SAFETY RECALL NOTICE

Cannondale C1 Front Brake Recessed Allen Nut Replacement

C1 FRONT BRAKE NUT REPLACEMENT INFORMATION

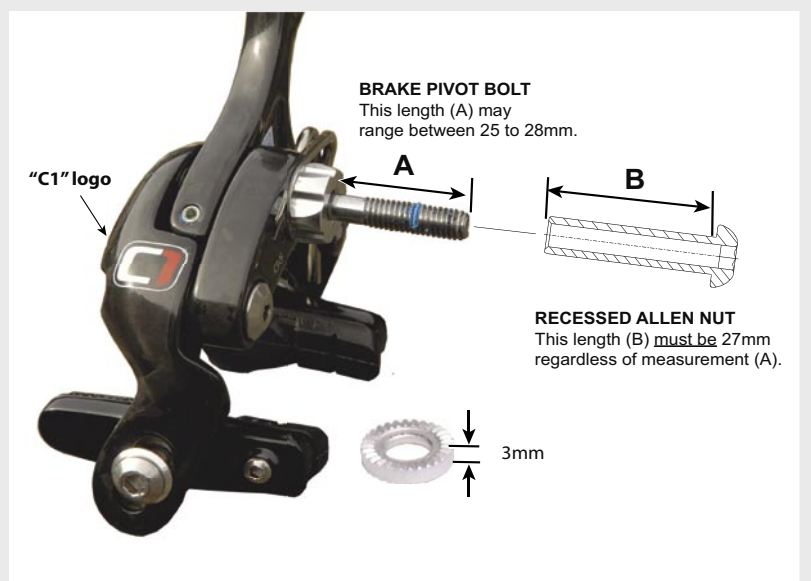
The Cannondale C1 carbon front brake on these 210 bikes may have been installed with a recessed allen nut that is too short resulting in insufficient thread engagement. The brake can detach from the bike.

The pivot bolt length "A" of the C1 carbon front brake can range between 25-28mm. For proper thread engagement, the brake must be installed with a 27mm recessed allen nut "B." On affected bikes, remove the nut and measure it as shown. If the nut is not 27mm, replace it with the 27mm recessed allen nut provided by Cannondale.

If you need the 27mm nut please order Cannondale kit number KR012/.

When reinstalling the brake, use only a single 3mm anti-rotation washer. Do not exceed 3mm or add other washers, fender brackets or install accessories as they will adversely alter critical bolt-to-nut thread engagement. Reapply Loctite 242 (blue) to the pivot bolt threads before brake reinstallation. Tighten the recessed allen nut to 69-87 InLbs (8-10N•m).
